South Jersey Transportation Planning Organization

2011-12 Road Safety Assessment

**Wildwood Traffic Signals
North Wildwood
Wildwood City
Cape May County**

April 20, 2012

PICTURES 17 & 18:
ATLANTIC AVENUE AND OAK AVENUE

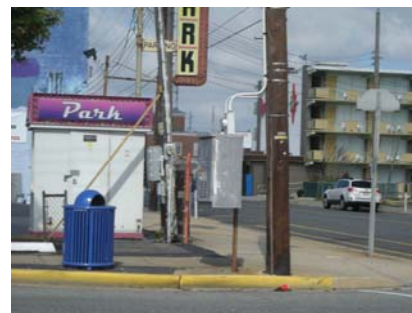
SAFETY ISSUE		REMEDIAL ACTION	LEVEL OF EFFORT REQUIRED			POTENTIAL SAFETY BENEFIT		
			LOW	MEDIUM	HIGH	LOW	MEDIUM	HIGH
6-4	There are handicap ramps on all of the corners of the intersection but they lack the detectable warning surface and may not be ADA compatible. The curb across the handicap ramp on the northeast corner is raised creating a possible tripping hazard.	Consideration be given to installing detectable warning surfaces on the handicap ramps and verify ADA compatibility. Correct height of curb on the northeast corner to eliminate tripping hazard.		X		X		
6-5	There are left turn slots along both of the Atlantic Avenue approaches to the intersection but no lane use control signs.	Install the appropriate lane use control signs.	X			X		
6-6	There are no signs at the intersection indicating that the Oak Avenue easterly approach is one way eastbound.	Install appropriate one way signs at the intersection.	X				X
